FORTUNE SYSTEMS CORP.
SERVICE NOTICE INDEX

FORTUNE SYSTEMS CORP

SERVICE NOTICE

Component Side View

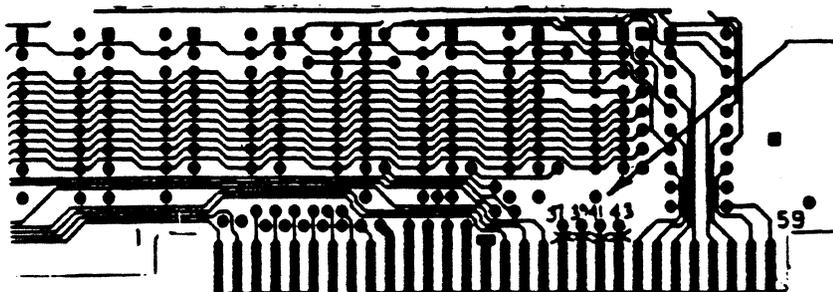
Cut traces exactly where shown. P1-37, P1-39, P1-41, P1-43.

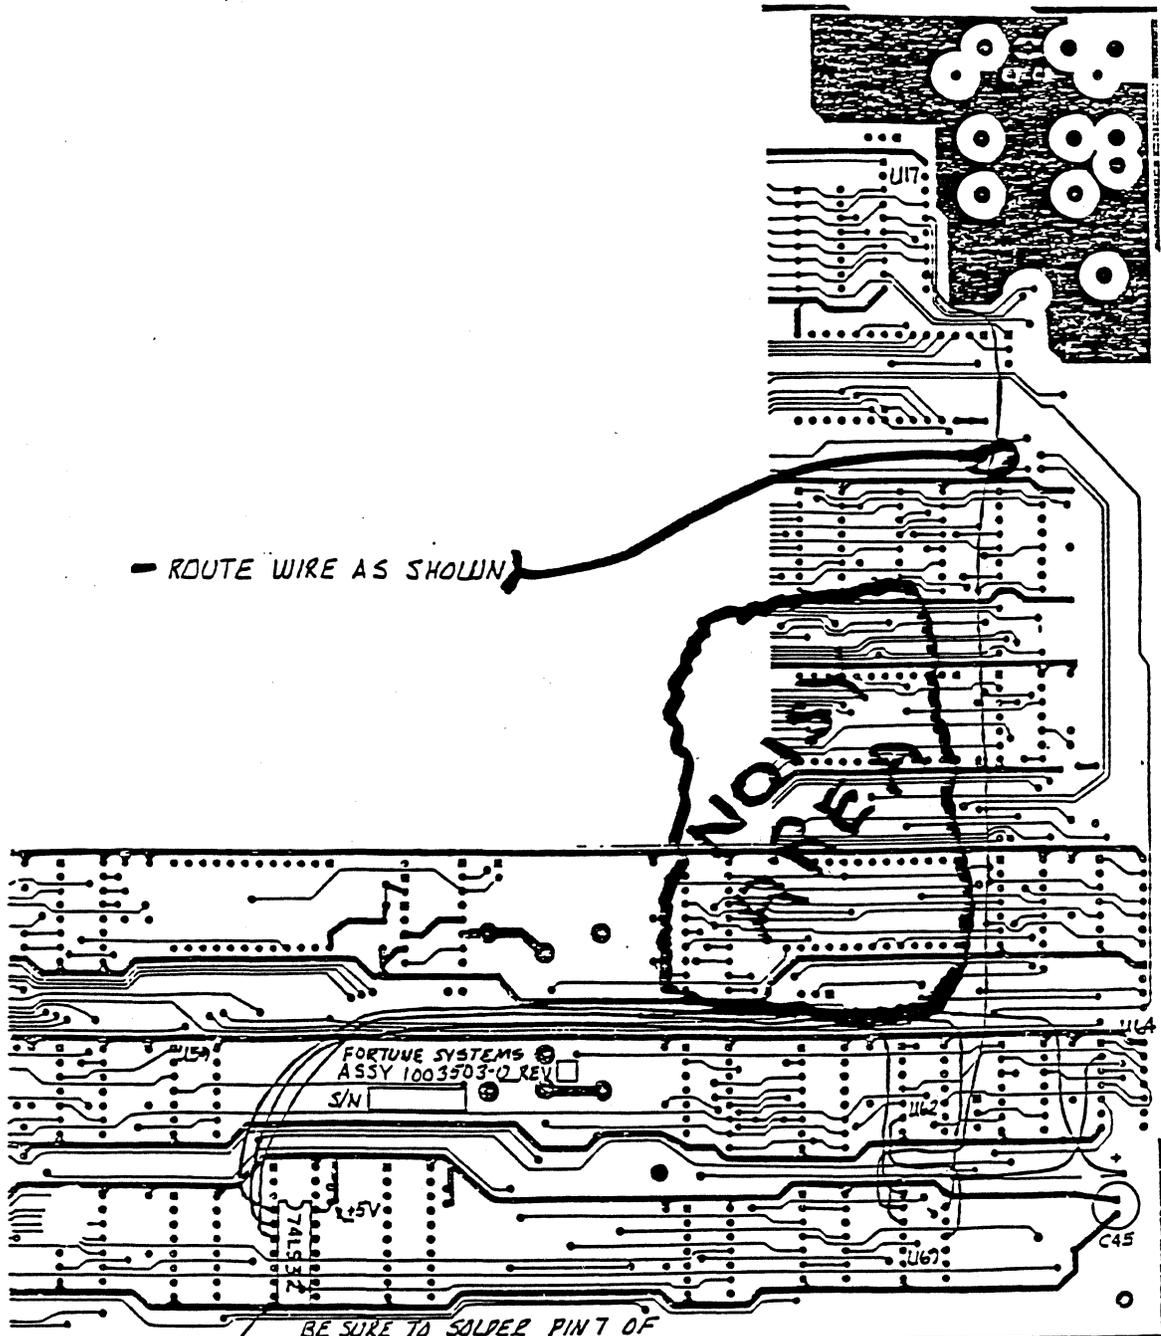
This problem will only happen if wire that runs from U17 to U69 is routed through noisy area on the PWA board..

If this symptom does arise the wire on the PWA board going from U17 to U69 (see diagram on page 2) will have to be physically moved out of the noisy area.

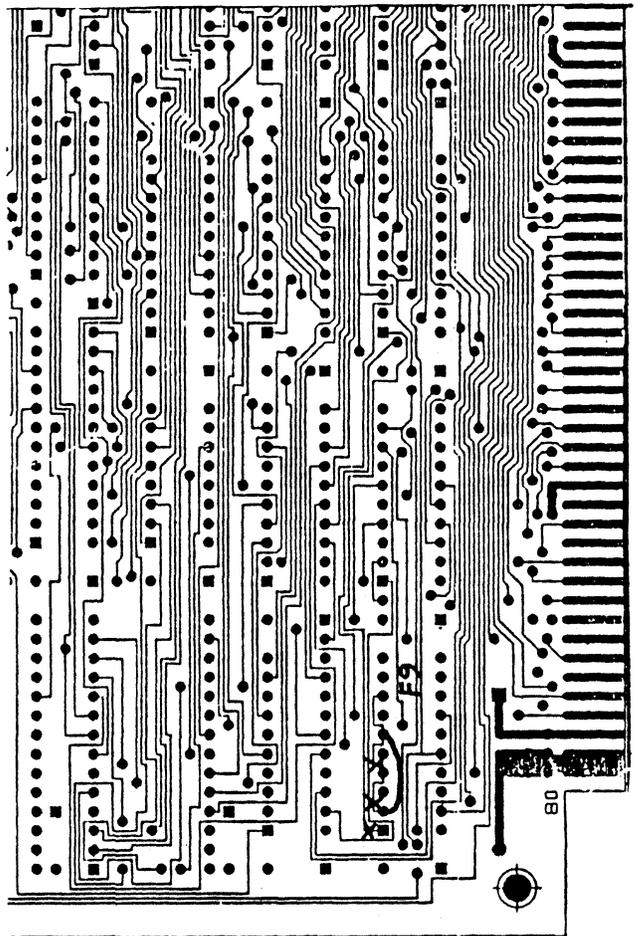
Cut Traces Exactly Where Shown.

COMPONENT SIDE

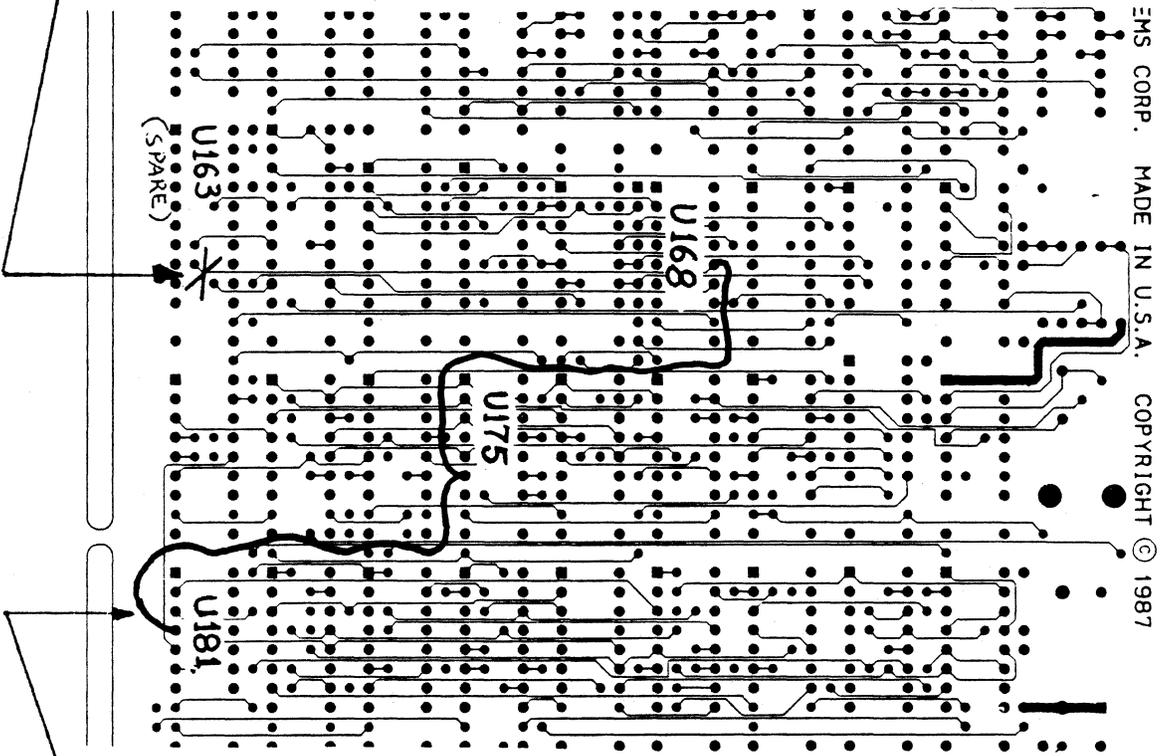
- 2. Cut trace exactly where shown.
Feedthru near spare IC location U163 pin 4.
